**Written submission from
Chris Houston**

**Regulatory Oversight Report for
Uranium Mines, Mills, Historic and
Decommissioned Sites in Canada: 2023**

Commission Meeting

January 29, 2025

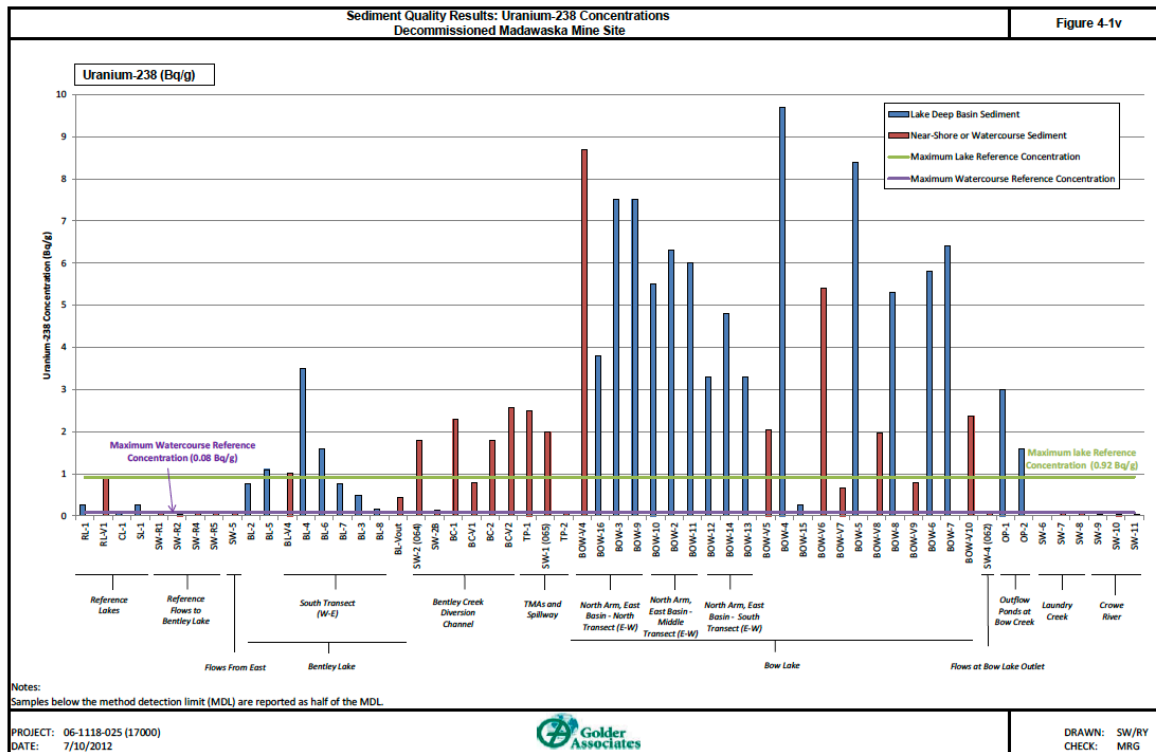
In 2012, uranium-238 concentrations in sediments of Bow Lake at sampling point BOW-V4 were measured at over 8 Bq/g. That is around 100 times the Maximum Watercourse Reference Concentration of 0.08 Bq/g and over eight times the Maximum Lake Reference Concentration of 0.92 Bq/g. Sediments in the deep basin were higher¹(see Figure 4-1v, overleaf).

FIGURE 2.3
URANIUM AND RADIUM-226 CONCENTRATIONS MEASURED IN
BENTLEY LAKE BETWEEN 1983-2004

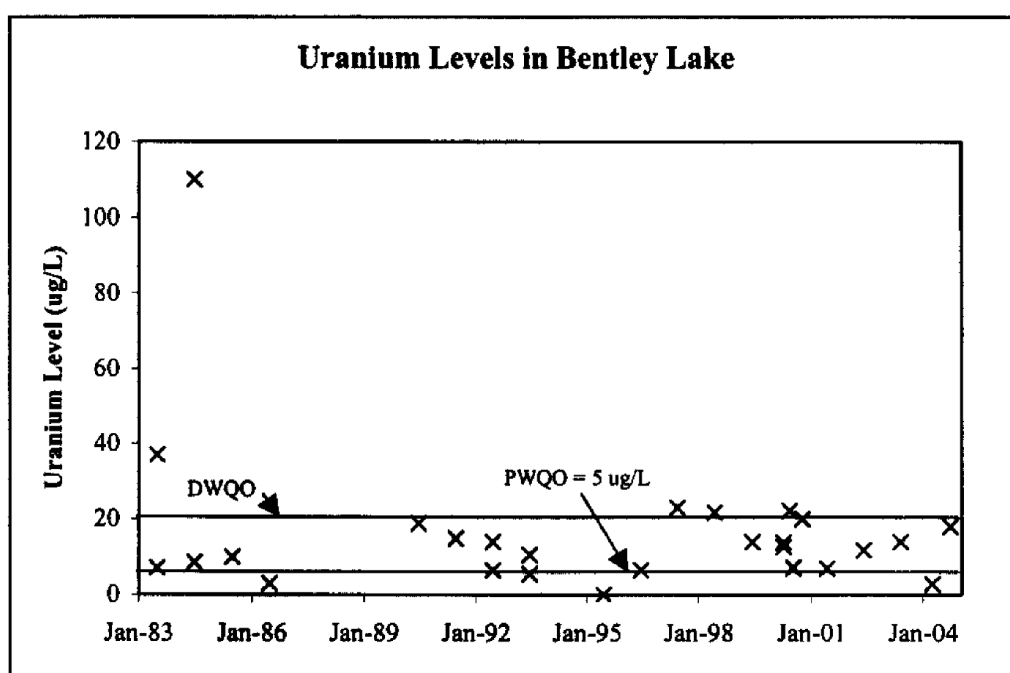
SENES Consultants' 2005 report *Pathways Analysis for Madawaska Mine Site* is not in the public domain. Page 2-8 (see graphic below) notes uranium levels in Bow Lake at around 70µg/L, thirty five times that of the Provincial Water Quality Objective of 5µg/L. Bentley Lake levels peak at around 110µg/L in the mid-1980s

The report states “there are potential risk of adverse health effects with respect to uranium for local residents.” The report states that the radiative doses “were below the regulatory limit of 1000µSv/y”. They ranged between 281 and 600µSv/y mostly from fish consumption. This is an area where people fish. The report does not state what quantity of fish are safe to eat. I have received no information about this important safety data point. Rehabilitation of Madawaska Mine started in 2015.⁵
